RENESAS TECHNICAL UPDATE

Product Category	MPU & MCU	Document No.	TN-16C-A190A/E	Rev.	1.00
Title	Errata to R32C/116 Group Hardware Manual		Information Category	Technical Notification	
Applicable Product	R32C/116 Group	Lot No.	Reference Document	R32C/116 Group Hardware Manual Rev. 1.00 (REJ09B0532-0100)

This document describes corrections to the R32C/116 Group Hardware Manual, Rev. 1.00.
The corrections are indicated in red in the list below.

Figure 8.1 Clock Generation Circuitry

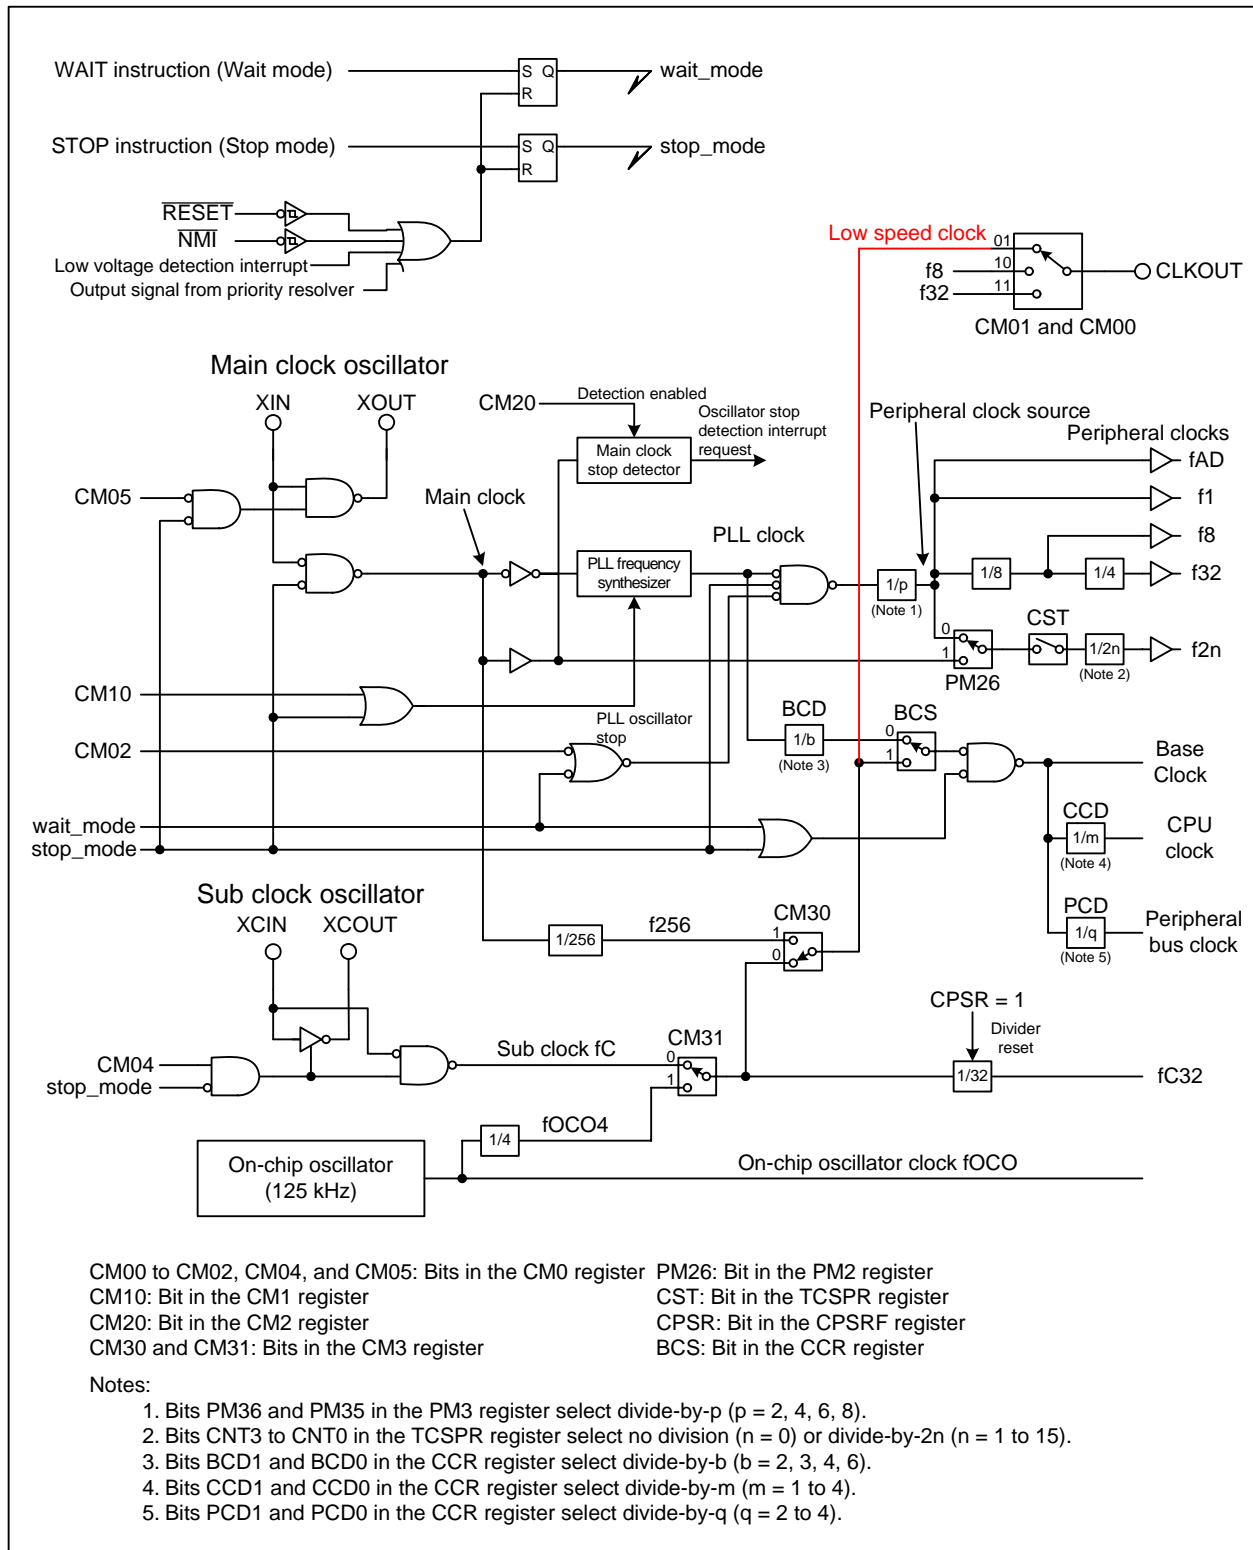
•Page 69 of 516, Figure 8.1 is corrected as follows:

Figure 8.19 State Transition (when the on-chip oscillator clock is used)

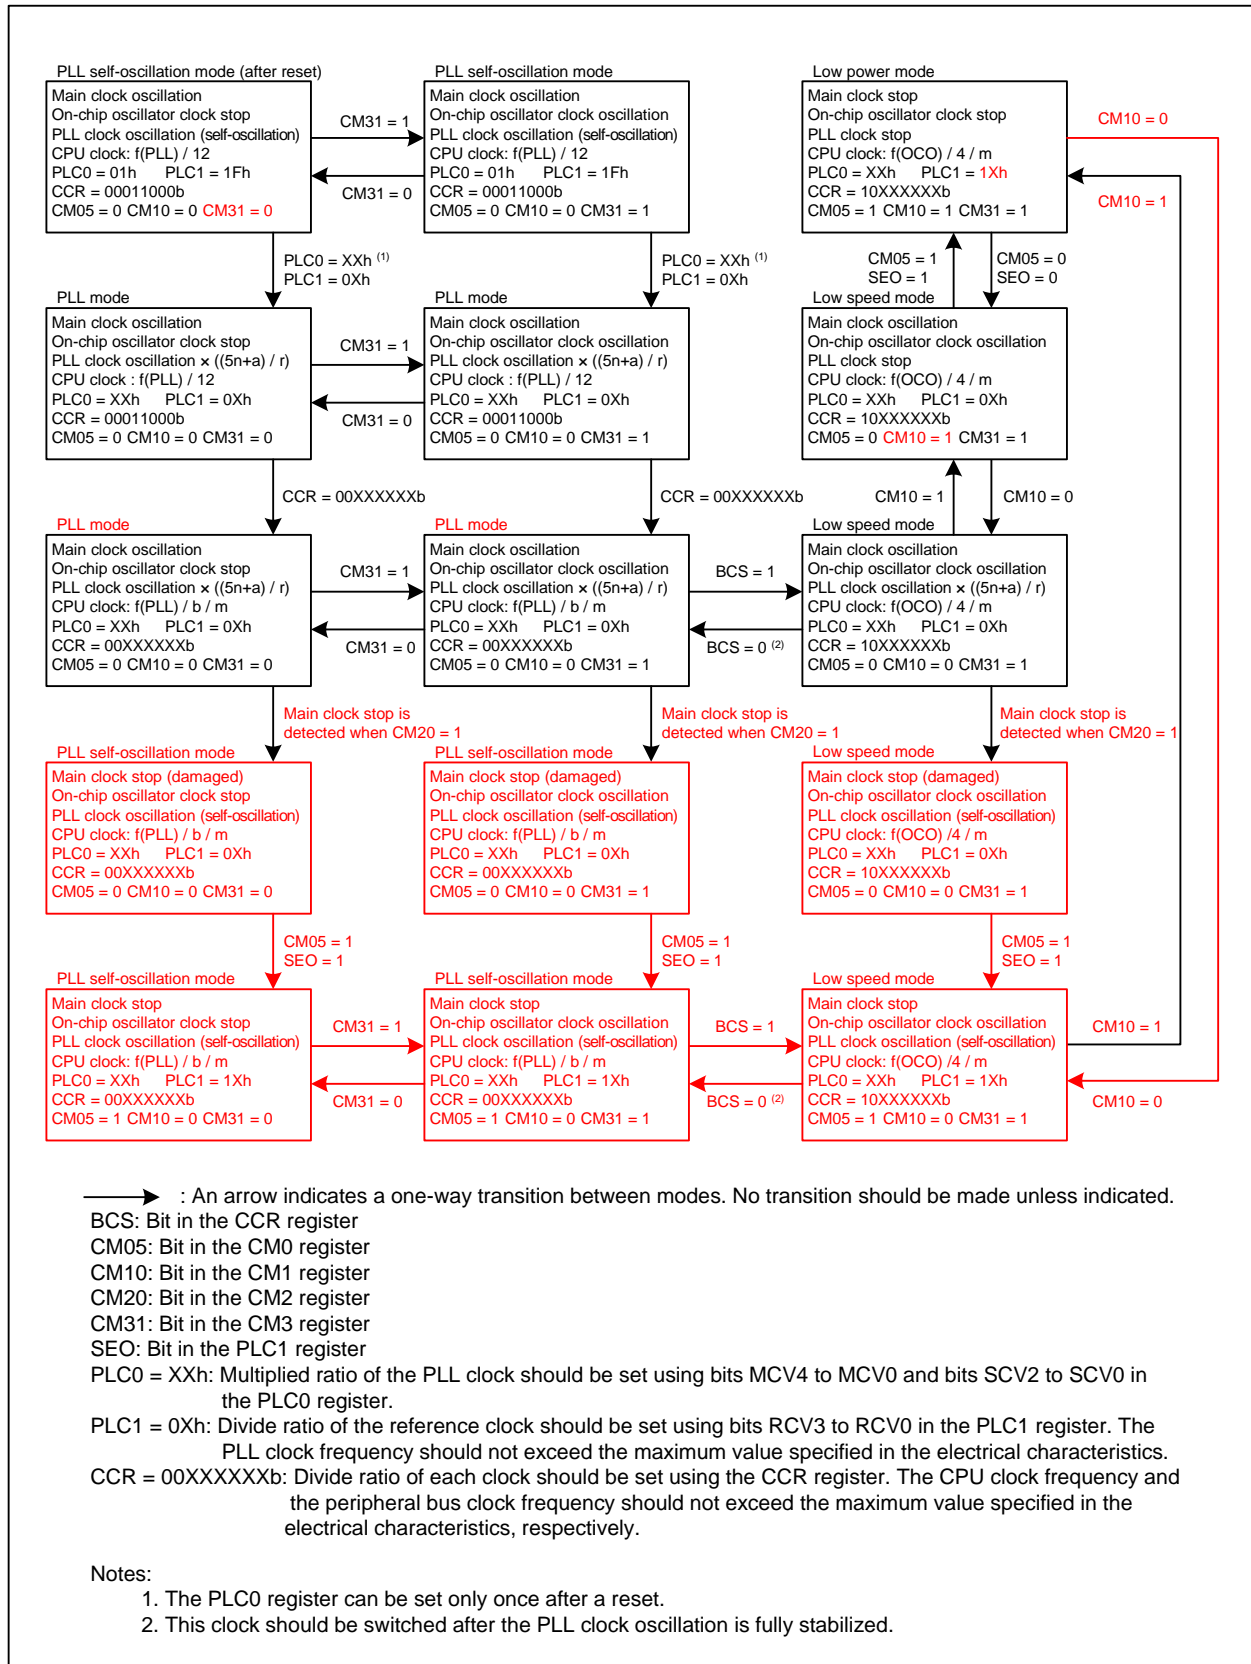
•Page 89 of 516, descriptions of “CM31 = 1” in the first row and “CM10 = 0” in the second row in Figure 8.19 are corrected, and the flowchart are clarified as follows:

(Note 3 “The CM05 bit is not set to 1 when an oscillator stop is detected through the oscillation stop detector.” is deleted from Figure 8.19)

Figure 9.15 ALE Signal and Address Bus/Data Bus

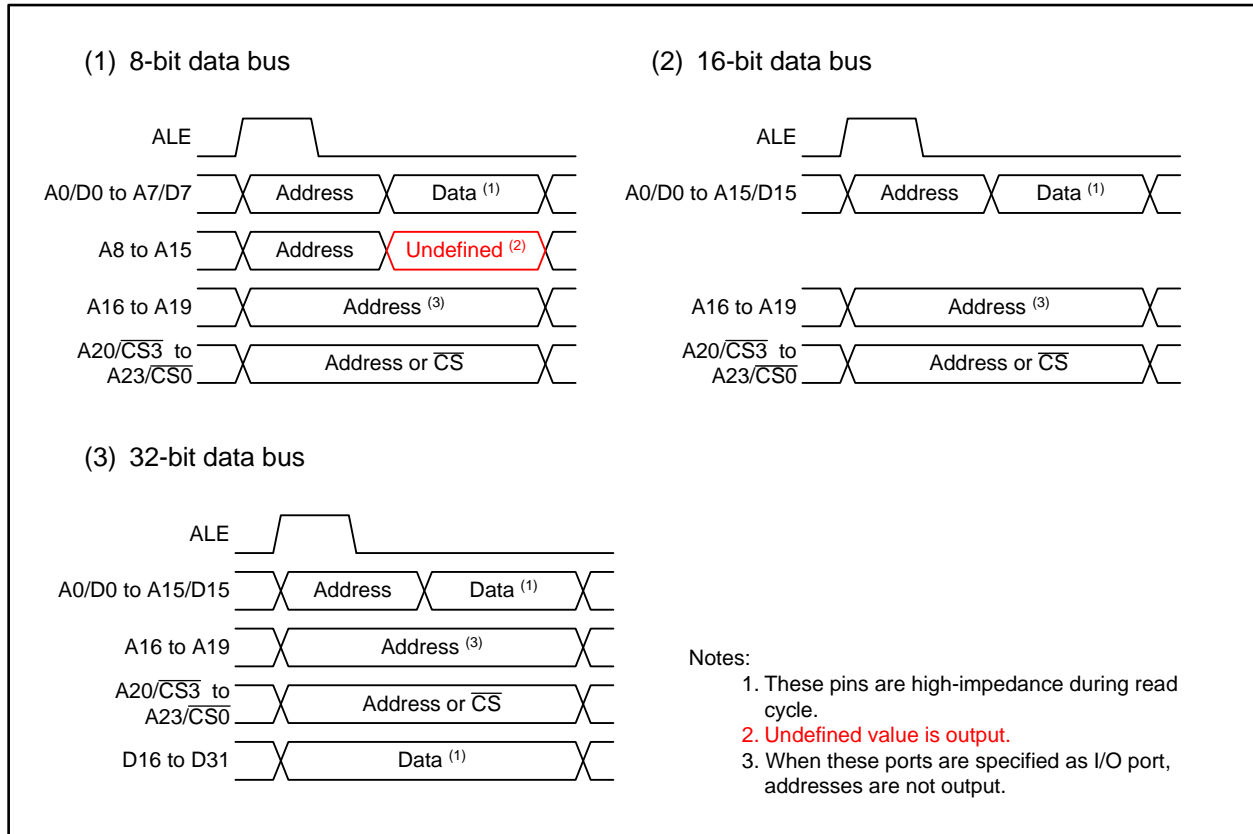
•Page 117 of 516, Figure 9.15 is corrected as follows:

Figure 11.8 Priority Resolver

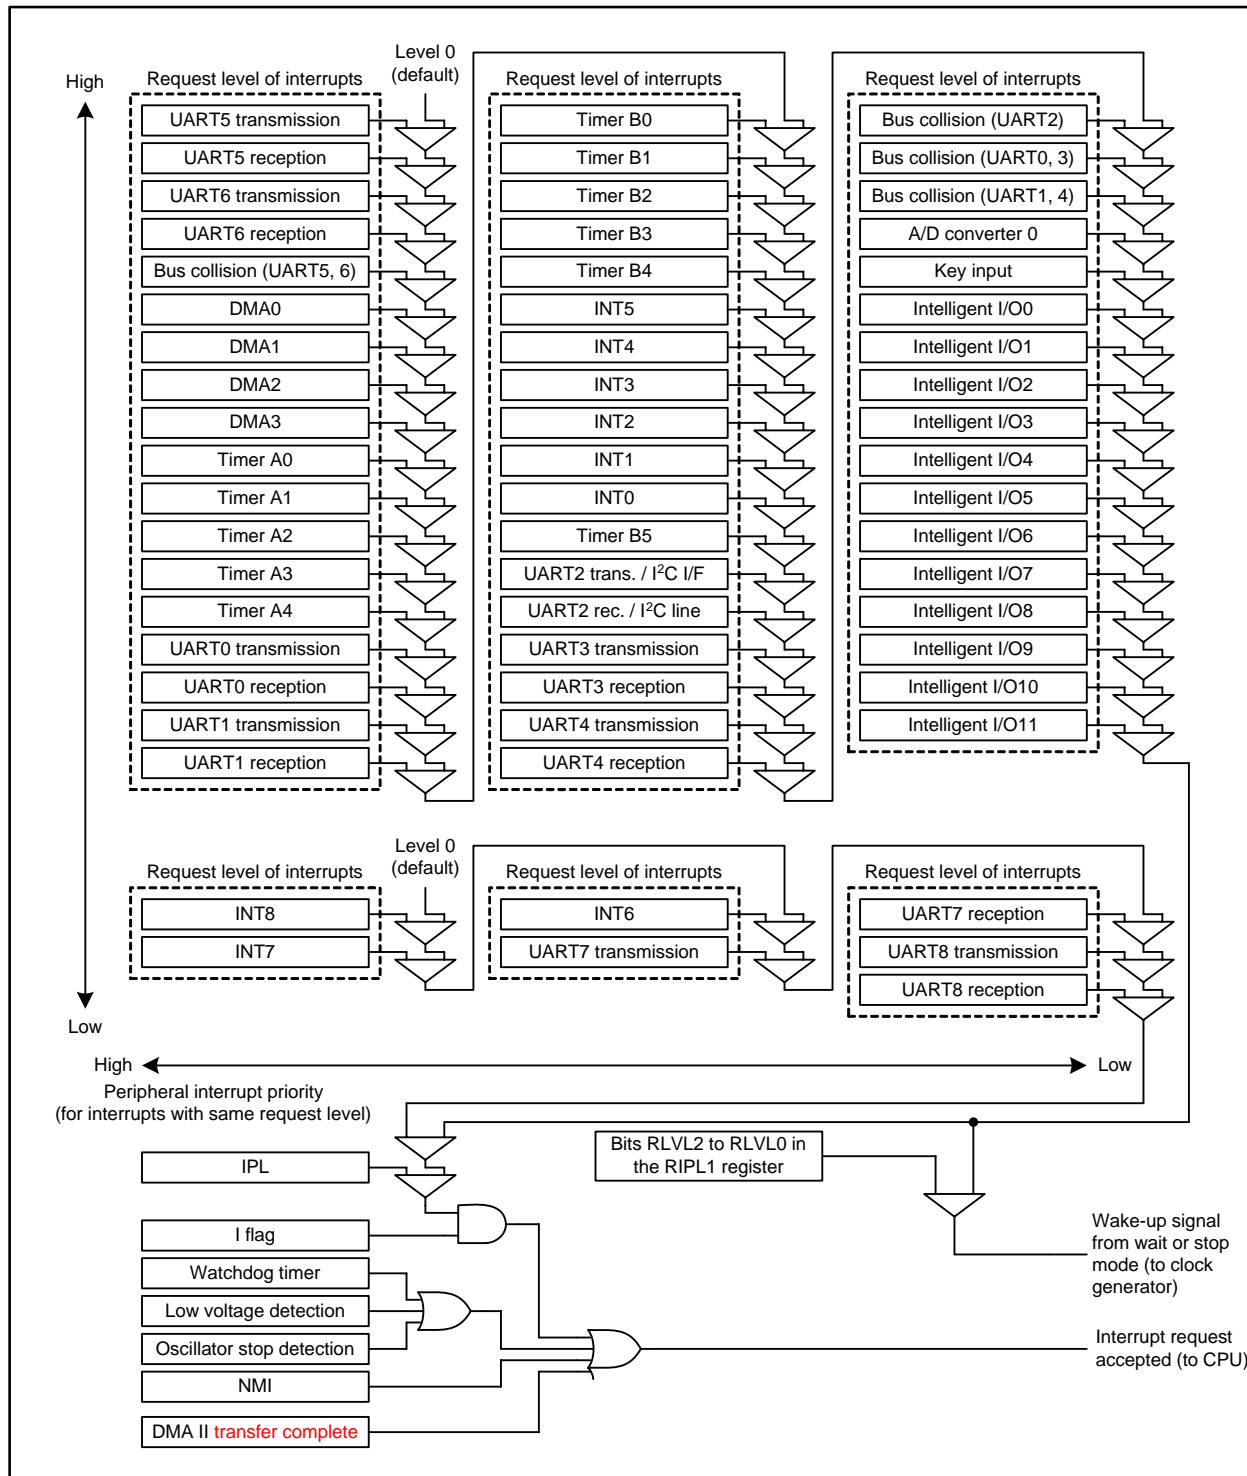
•Page 144 of 516, Figure 11.8 is corrected as follows:

(Description “Bits RLVL2 to RLVL0 in the RIPL2 register” and associated signal lines are deleted from Figure 11.8)

Figure 16.2 Timer B Configuration

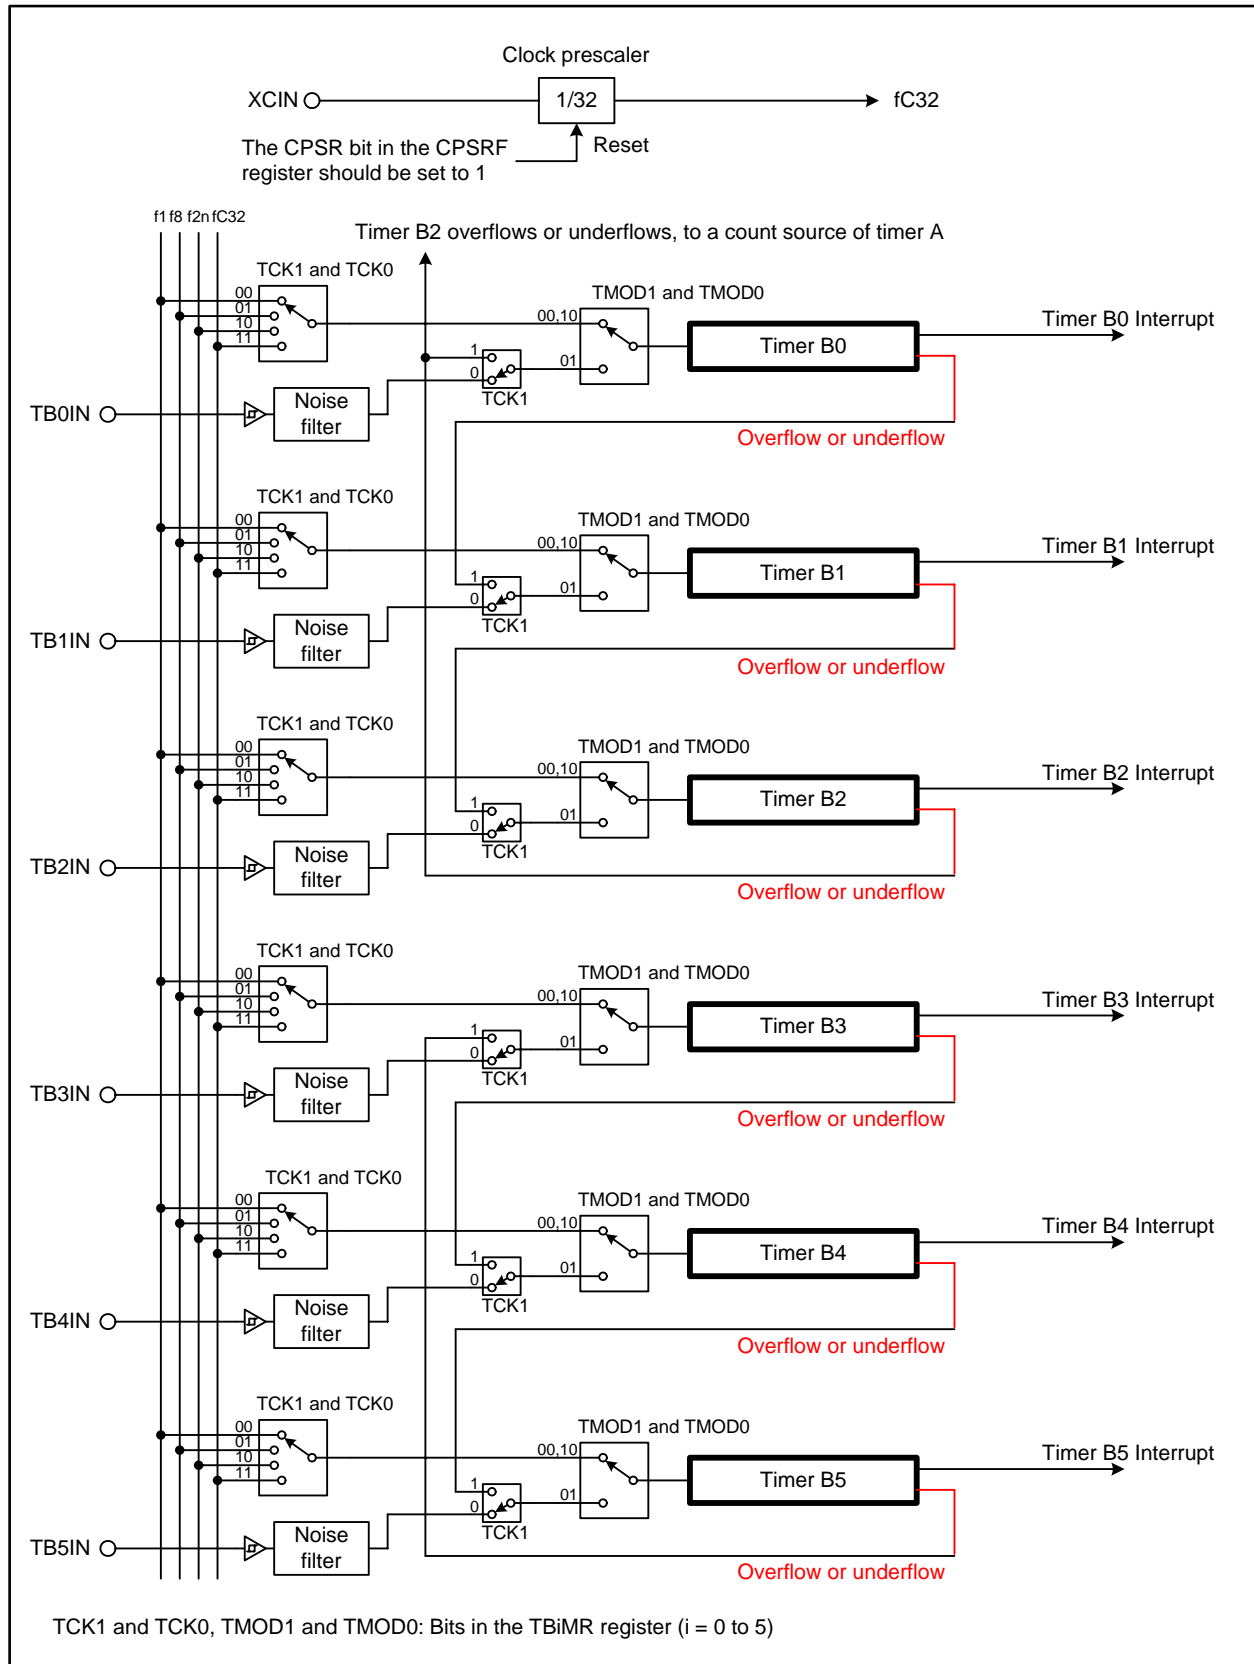
•Page 182 of 516, Figure 16.2 is corrected as follows:

Figure 26.13 Read Timing

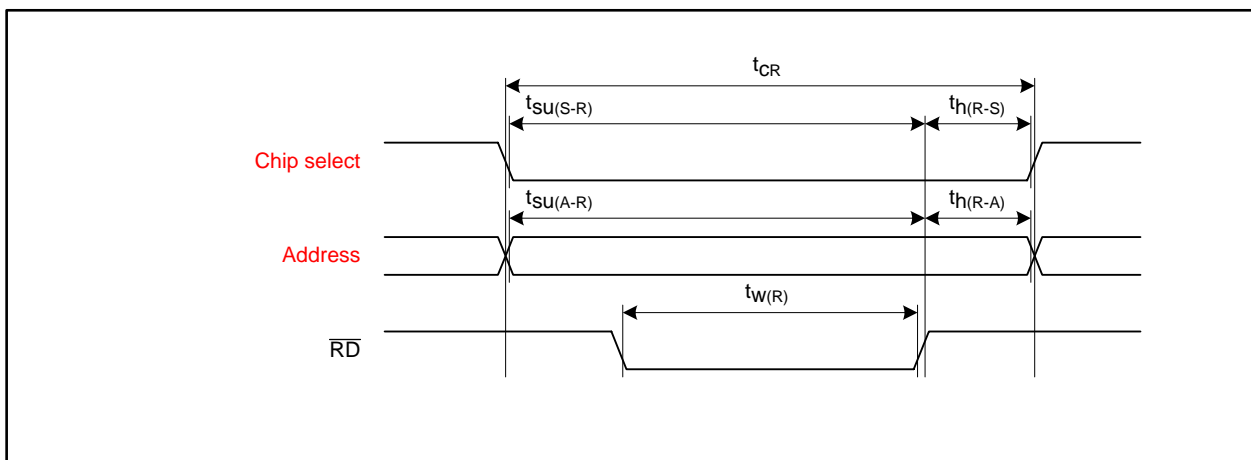
•Page 436 and 438 of 516, descriptions in Figures 26.13, 26.14, and 27.5 are corrected as follows:
